PRODUCT CHANGE NOTIFICATION

#PCN-DC-875K-13

Changing of the shape on the mating area and solder area for the M12 DSI wave soldering contacts.

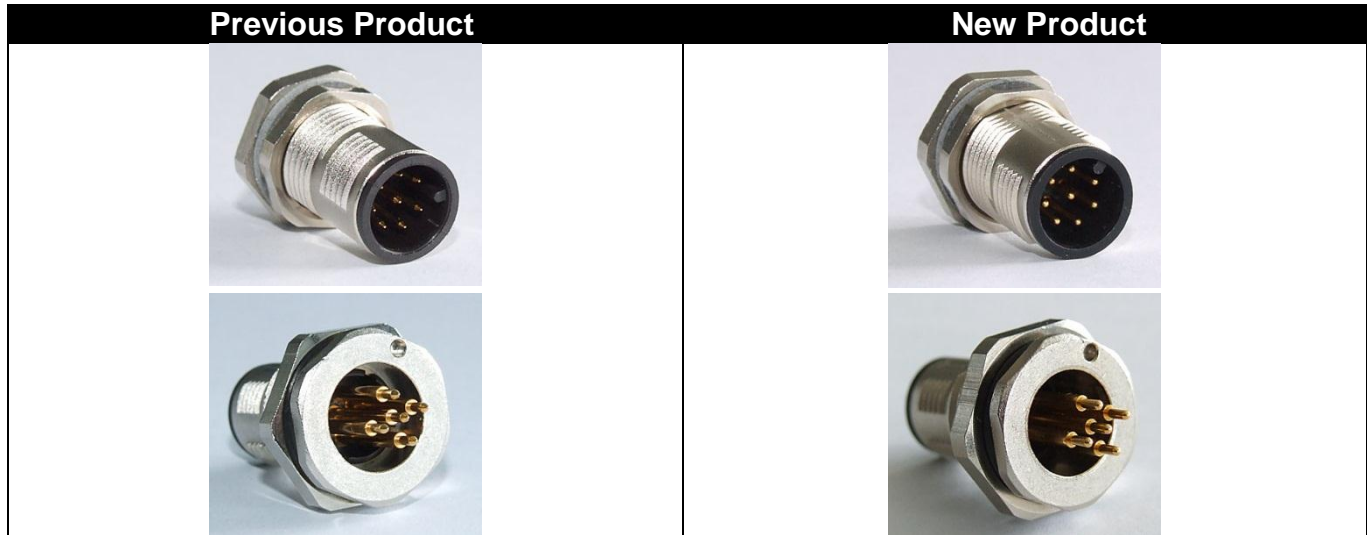
The male and female (4- up to 8-pins) for the wave soldering process, the sharp shape of the contacts have to be changed into a round shape on the mating and soldering area.

The reason for this is new optimized production process. The technical features are completely compatible. The change flows smoothly into the existing series.
